RE: 75-83 Court Street – Response to Department of Planning and Development June 27<sup>th</sup>  
Memo

Per the request of your department following the June 26<sup>th</sup> public hearing on the Court Street 40B application, we have prepared a written response to the June 27<sup>th</sup> memo issued by Alexandra Ananth and Steven Pantalone.

RE: 75-83 Court Street – Summary of Key Plan Changes

# Images / Westerly Side facing Verizon Parking Lot

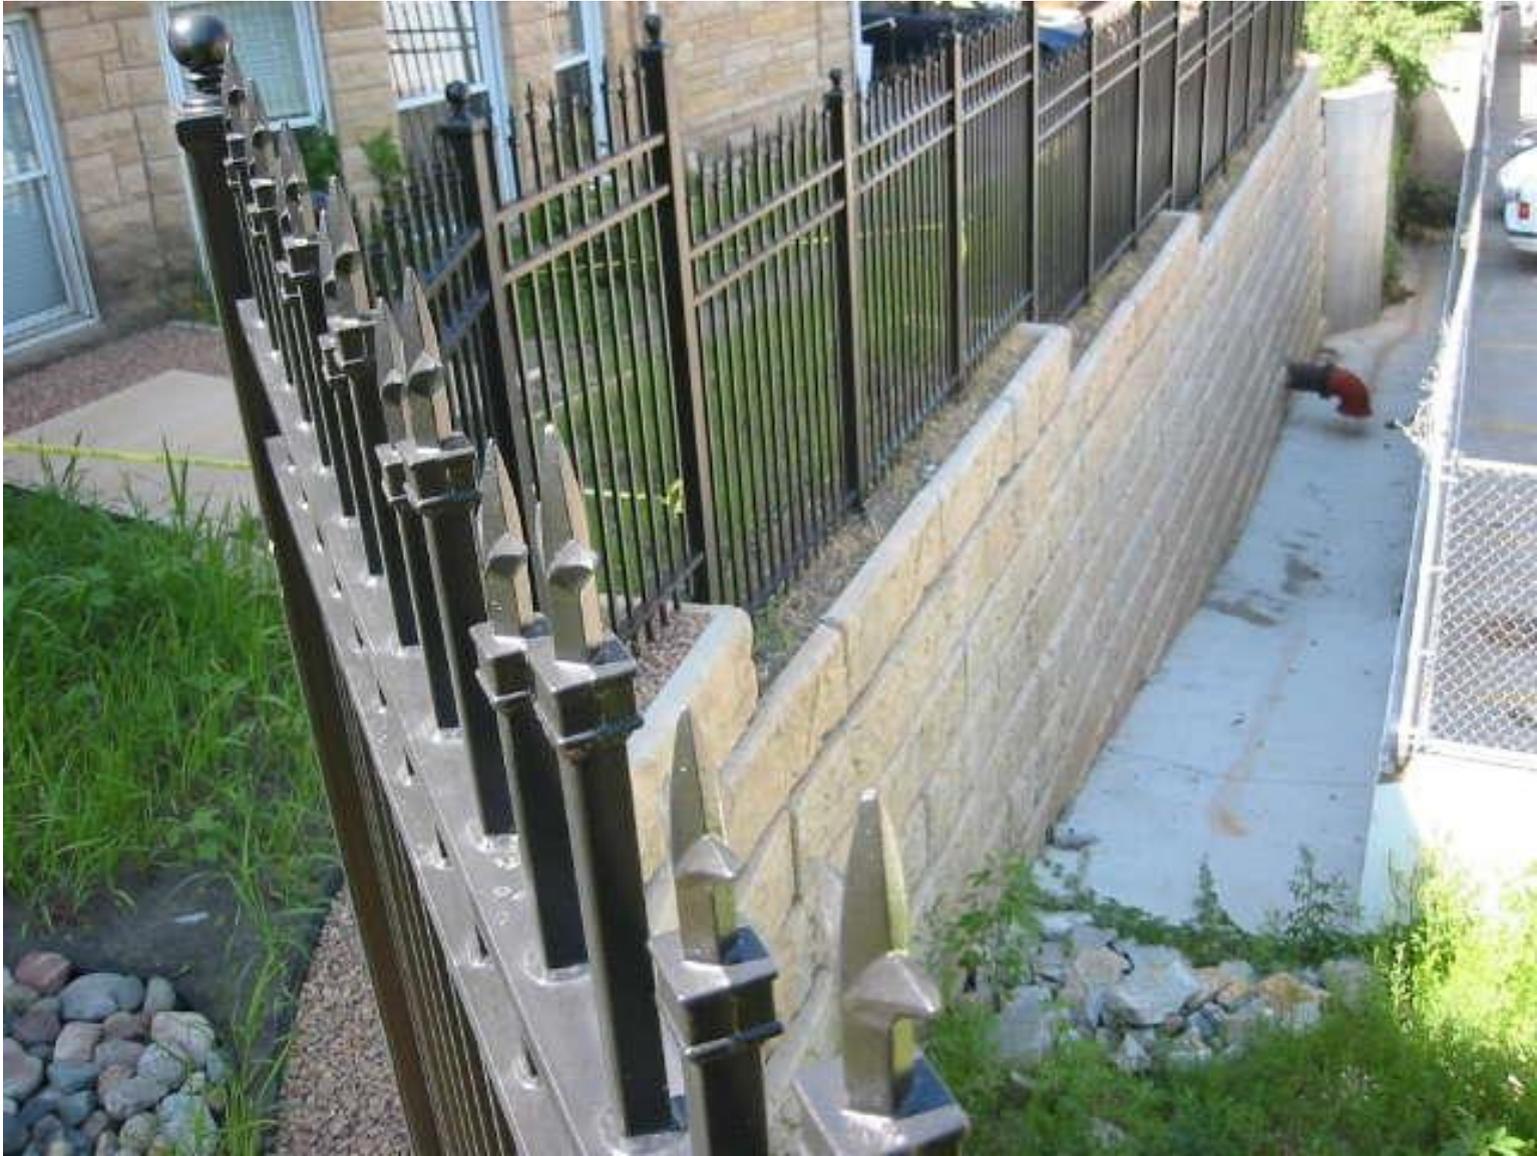
- C. **The applicant** should respond to requests to increase the amount of open space on site. Can the applicant provide a cross section showing the retaining wall and open space on the west side of the site? The applicant should explain how the area west of the retaining wall on the western property line will be maintained. The Planning Department would also like to see a cross section for the east side of the site to illustrate how the project will impact the immediate abutter. The applicant should consult with the abutter to the east on landscaping between the two properties.

*An exhibit (Labeled as Attachment "D") has been attached to this submission which includes photographs of what the retaining wall to the west of the property (towards the Verizon parking lot) would look like. The space between the wall and the lot line will be 2'. In speaking with the retaining wall manufacturer, there will be no maintenance required for this wall as there will not be any heavy salting around that area.*

# Autumnal Equinox 4:30 pm

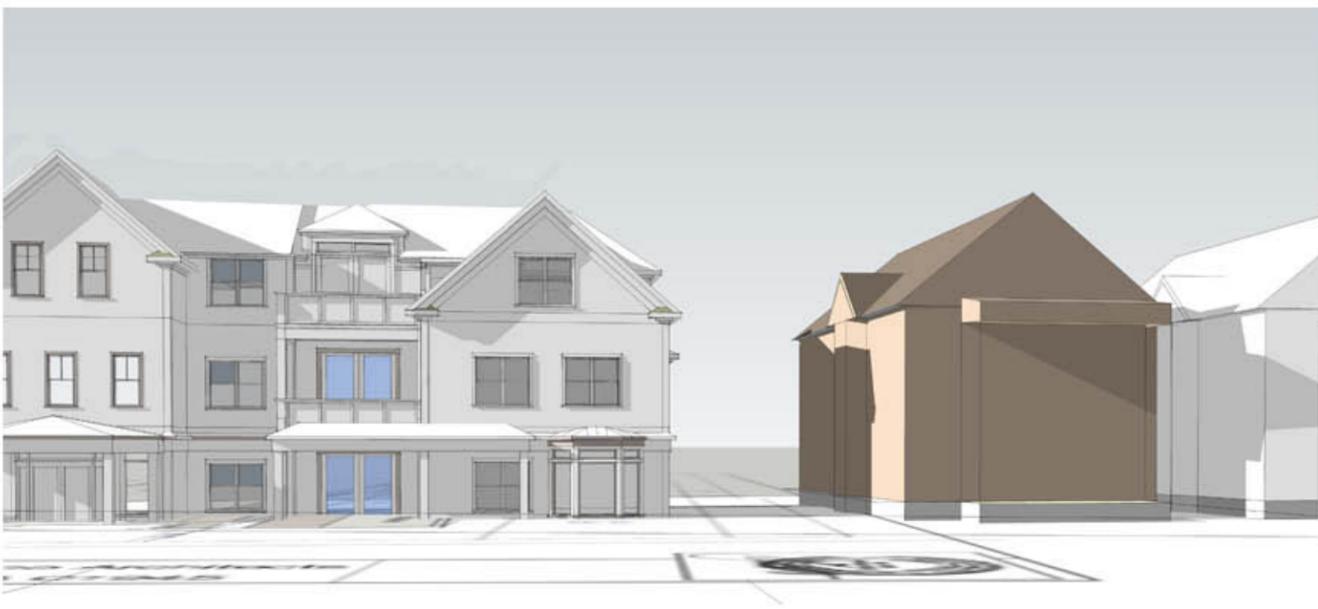
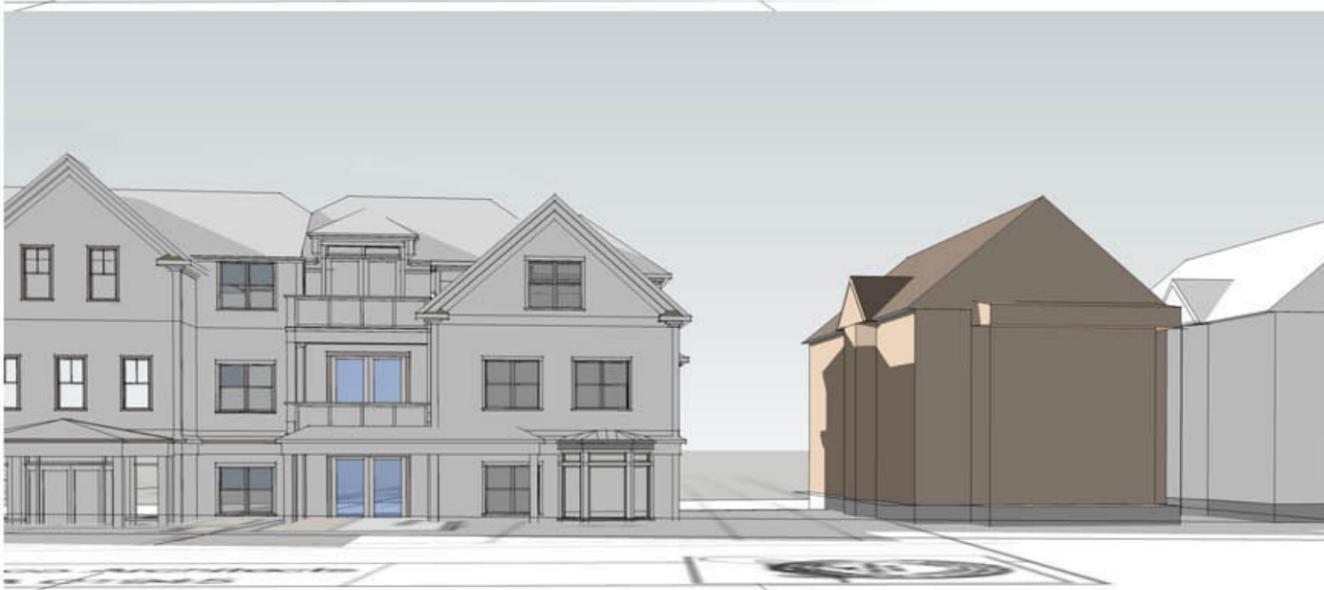
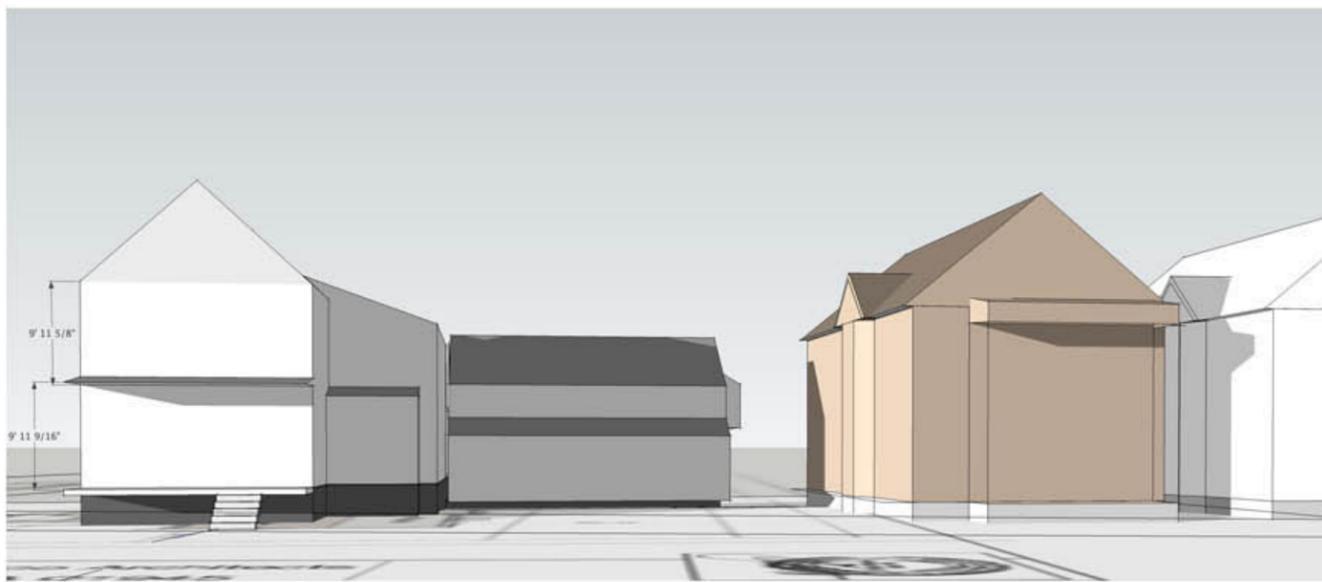
- C. **The applicant** should respond to requests that waivers to the Light Trespass and Tree Preservation Ordinances be removed from their application. The applicant should submit plans addressing these waivers as well as a plan for signage. A shadow study should also be provided.

*The Applicant has submitted a shadow study (Attached "E"). The analysis indicates the proposed development, particularly with an increased side setback, will have cast minimal shadows on 69 Court Street – which is the only proximate residential abutter. Moreover, the shadows cast will be far less than the shadows cast by an allowable special permit development which would allow for a 35' structure 15' from the property line. In addition, the shadows cast by 69 Court onto 67 Court Street and vice versa are much more significant at all points of the day than the shadow cast by the proposed development.*
